APPENDIX C

RETROFIT PLAN FOR COTTAGES AT AZALEA APARTMENTS

Safe Harbors used to develop the retrofit scope:

Surveyed Unit 117C, 120B- Typical for 20 total units

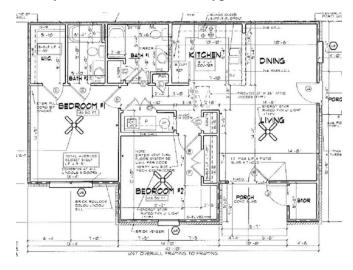
20	S course 3 4 55

Entrance door threshold exterior side at Unit 120B.

Door thresholds are more than 3/4 inches high at the exterior face and are not beveled (maximum 3/4 inch with bevel allowed).

Height
Location	(inches)
Unit 117C, storage	1-3/8
Unit 120B, entrance	1

At unit entry doors:

Provide beveled transition strips.

At storage doors:

Provide beveled transition strip or offer remediation upon request of tenants. If offered on tenant request, a durable-material placard, contrasting black text on white background, in minimum 14-point font, must be placed on the side of the patio door stating: "A BEVEL TO ASSIST PERSONS WITH DISABILITIES FOR THIS

Vanity base in Unit 120B.

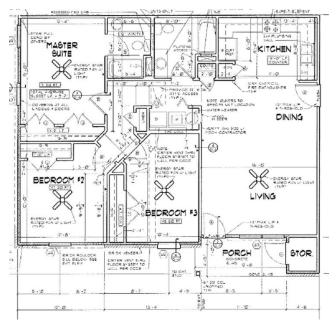
Clear door opening.		
22	Dimension from side wall to centerline of lavatory in Unit 117C.	The lavatory centerlines are less than 24 inches to the side wall (minimum 24 inches required) and the cabinets are not removable. Distance Location (inches) Unit 120B bathroom. 18-3/4	Install removable base cabinet at lavatory. Attach a durable-material placard stating: "THIS CABINET IS REMOVABLE FOR PERSONS WITH DISABILITIES. CONTACT MANAGEMENT."

Storage door threshold exterior side at Unit 116C.

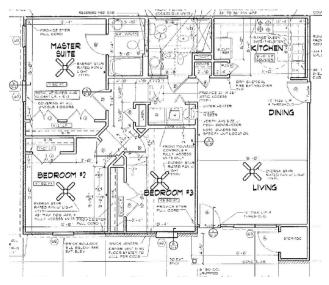
Door thresholds are more than 3/4 inches high at the exterior face and are not beveled (maximum 3/4 inch with bevel allowed).

Height
Location (inches)
Unit 116C, storage 1-1/2

Provide beveled transition strip or offer remediation upon request of tenants. If offered on tenant request, a durable-material placard, contrasting black text on white background, in minimum 14-point font, must be placed on the side of the patio door stating: "A BEVEL TO ASSIST PERSONS WITH DISABILITIES FOR THIS THRESHOLD IS AVAILABLE UPON REQUEST. CONTACT MANAGEMENT."
